# Access Compliance Report Public Rights-of-Way (Curb Ramps)

**Main Street:** SIENNA\_PKWY      **Cross Street:** WALDEN\_ST      **Location:** NE

**ADA ID:** RPRK211020174128      **Ramp Type:** Type 1 - Perpendicular Diagonal Initial Pass/Fail: Fail      **Overall Compliance:** No      **Severity Score:** 2

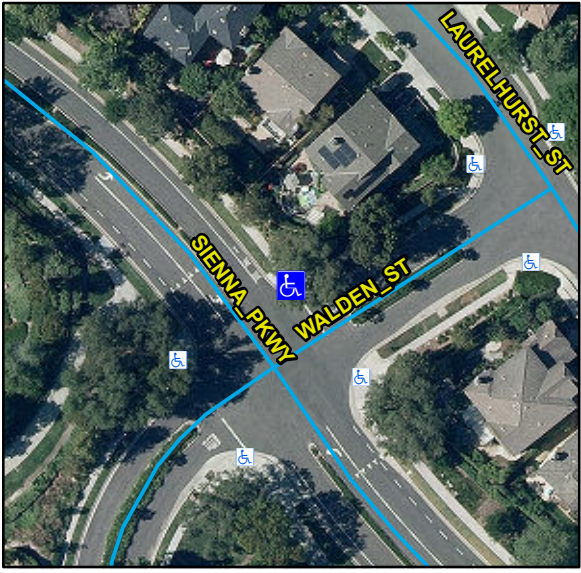
**OC Std/PROW:**  
 R304.2.2, R204.3, R304.5.3, STD 1115

Compliance	Description	Data	Compliance	Description	Data
N/A	Ramp Length (in)	128	N/A	Flare Type LT	
Yes	Ramp Width (in)	48			N/A
Yes	Ramp Run Slope (%)	5.9	N/A	Flare Slope LT (%)	N/A
No	Ramp Cross Slope (%)	2.5	N/A	Flare Traversable LT	N/A
N/A	Landing Present	N/A	N/A	Flare Type RT	
N/A	Landing Length (in)	N/A			N/A
N/A	Landing Width (in)	N/A	N/A	Flare Slope RT (%)	N/A
N/A	Landing Run Slope (%)	N/A	N/A	Flare Traversable RT	N/A
N/A	Landing Cross Slope (%)	N/A	N/A	DWS Provided	N/A
N/A	Landing Movement Obstructed?	N/A	N/A	DWS Contrast	N/A
	Landing Movement Type	N/A	N/A	DWS Length (in)	N/A
N/A	Landing Shared	N/A	N/A	DWS Full Width	N/A
N/A	Clear Space	Yes	N/A	DWS Offset Left (in)	N/A
N/A	Clear Space To Crosswalk (in)	N/A	N/A	DWS Offset Right (in)	N/A
N/A	Marked Crosswalk 1	No	N/A	Marked Crosswalk 2	No
	Crossing 1 Direction	W		Crossing 2 Direction	S
	Marked Crosswalk 1 Width (in)	N/A		Marked Crosswalk 2 Width (in)	N/A

**Possible Solutions:**  
**Remove & Replace Curb Ramp With Two New Directional Ramps or Equivalent.**
